January 10, 2017

RE: Former D-F Property  
2517 E. Norwich Avenue  
St. Francis, Wisconsin  
BRRTS# 02-41-097173  
FID# 241239460

LF Green has prepared the enclosed tables and figure to summarize modifications to the Site Investigation Work Plan dated October 6, 2016 in accordance with the recommendations you provided in your letter dated November 16, 2016. Attached please find the following:

<b>GROUNDWATER CONTOUR MAP (10/15/2012)</b> 2517 EAST NORWICH ST. FRANCIS, WISCONSIN	FIGURE <b>2</b>
---	---	--------------------

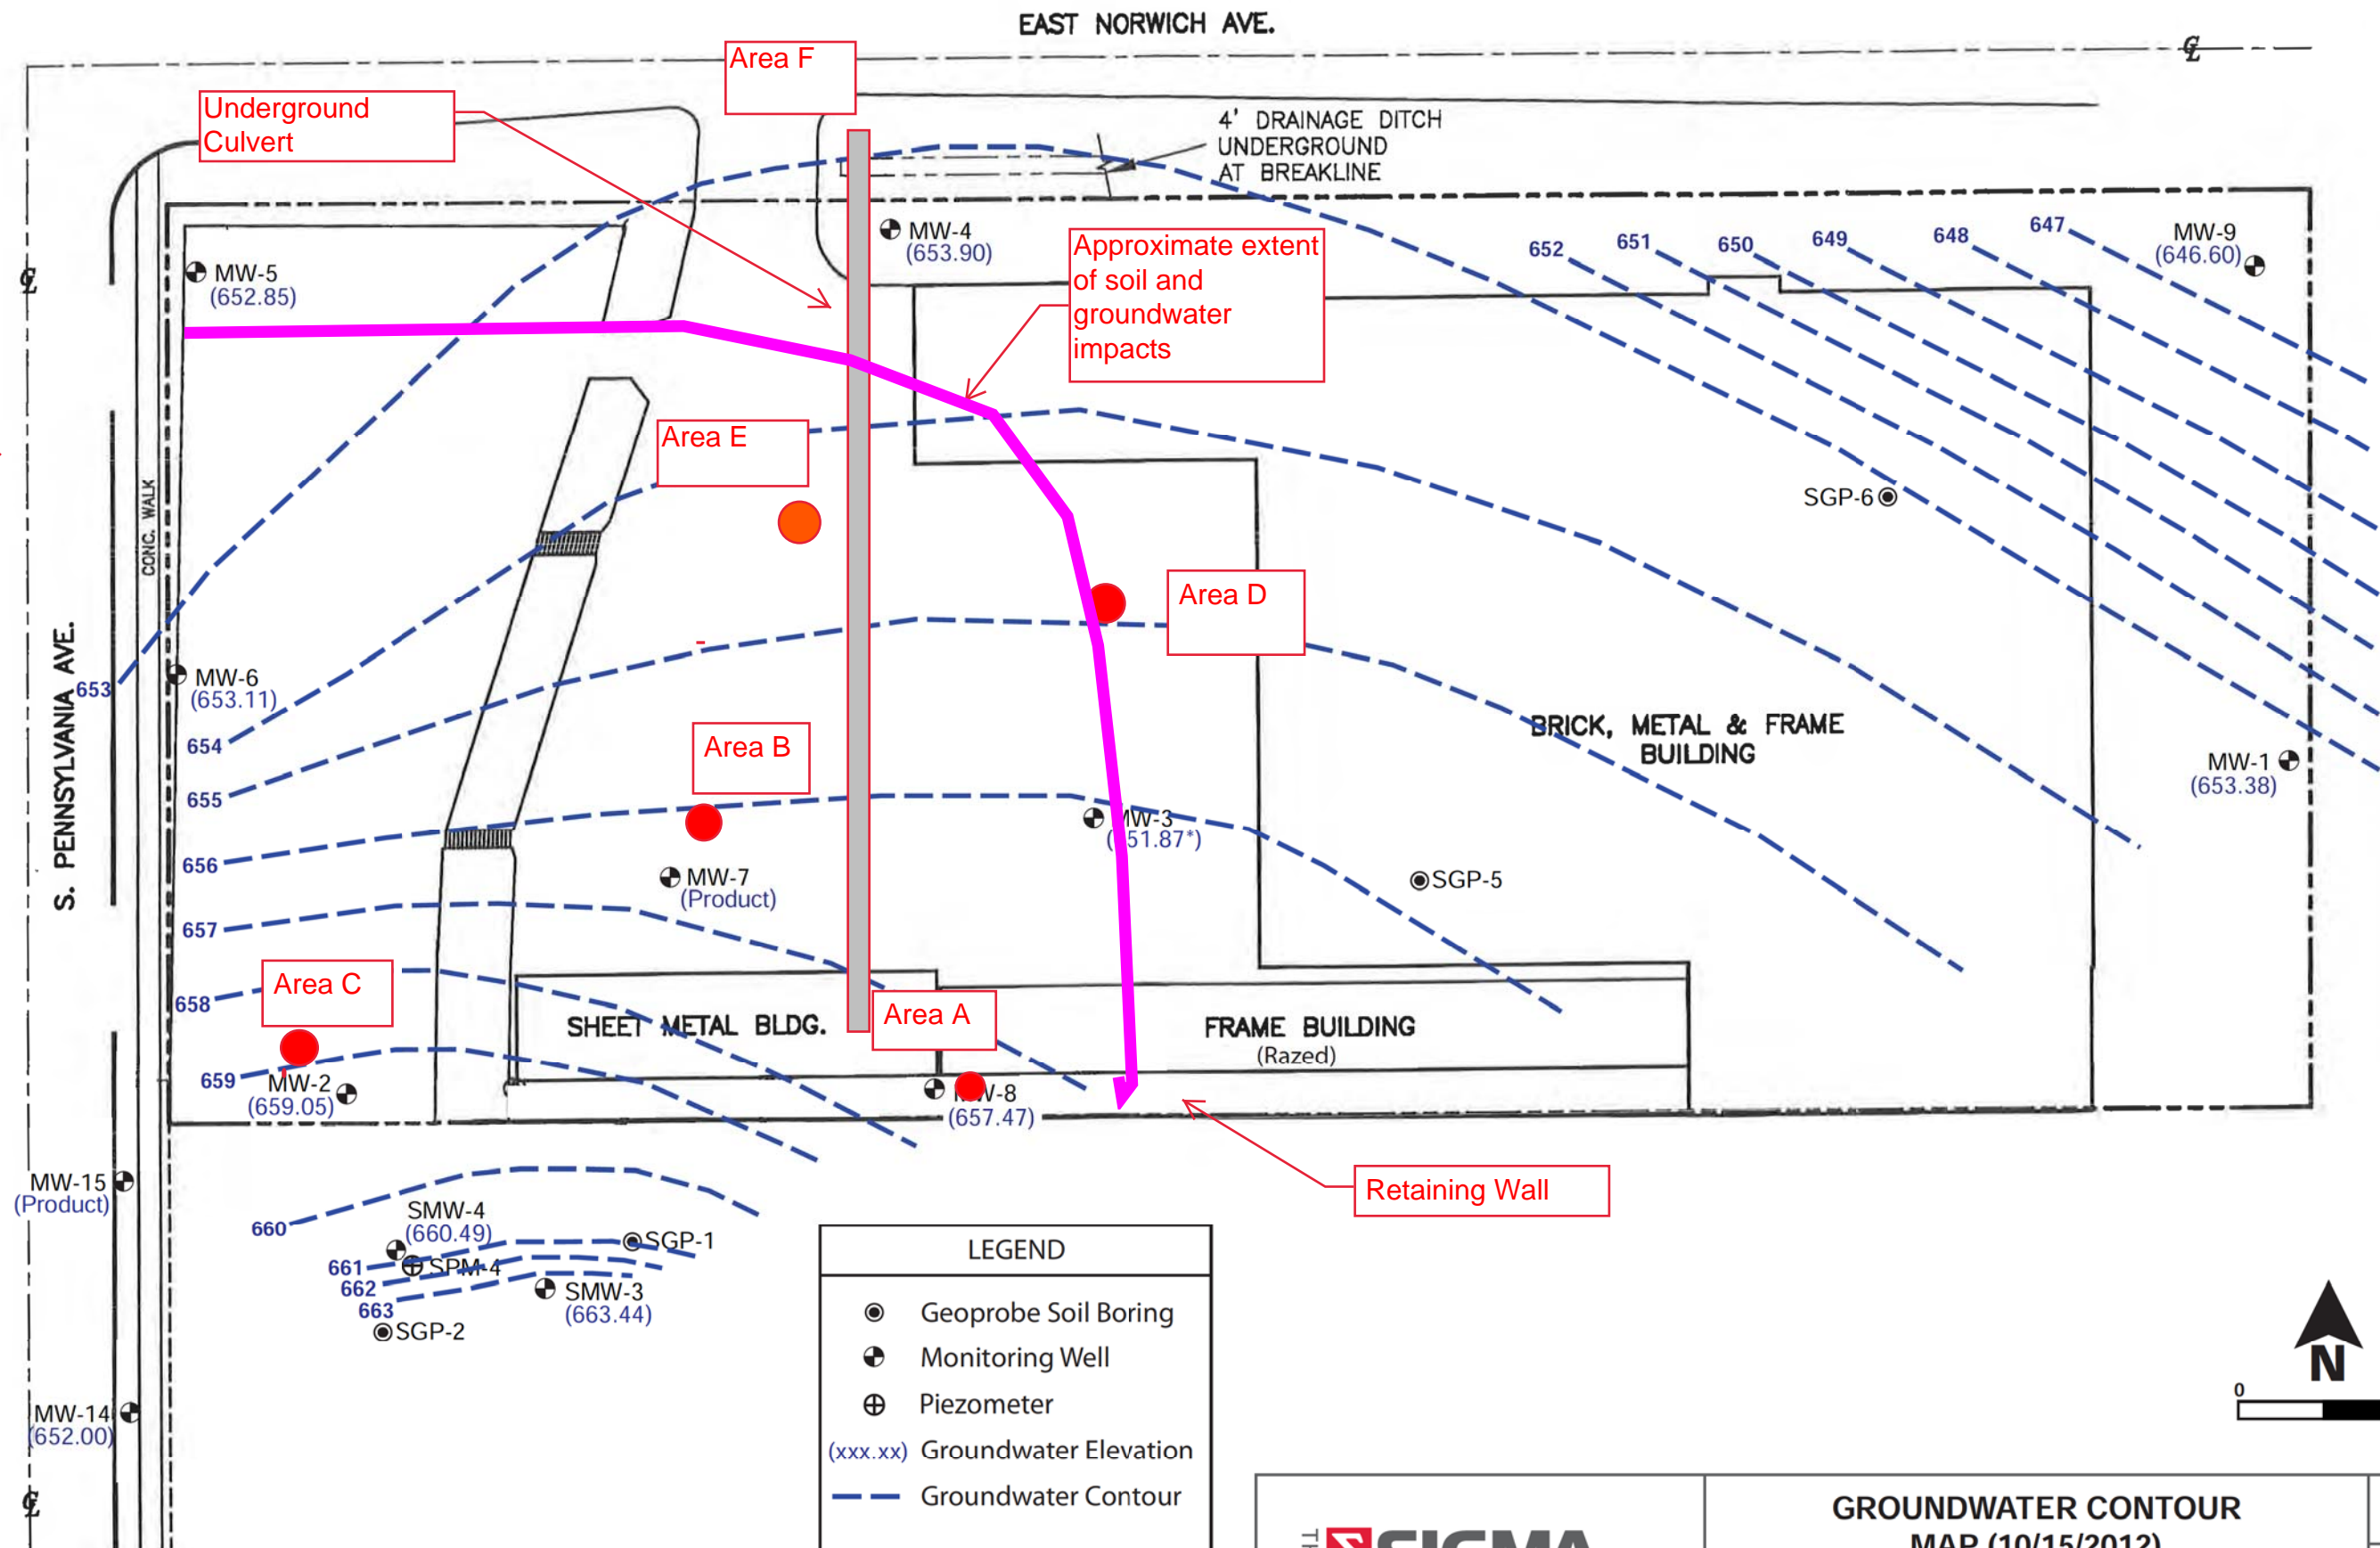
- Figure 2: SIGMA Groundwater Contour Map depicting areas of proposed site investigation, summarized in Table 2. This figure has been revised to depict the approximate location of the underground concrete culvert and the approximate location of a monitoring well to define the northerly extent of contamination north of MW-7. We have also added a temporary monitoring well to be installed and sampled near the outfall of the concrete culvert as it discharges to the Norwich Avenue drainage ditch.
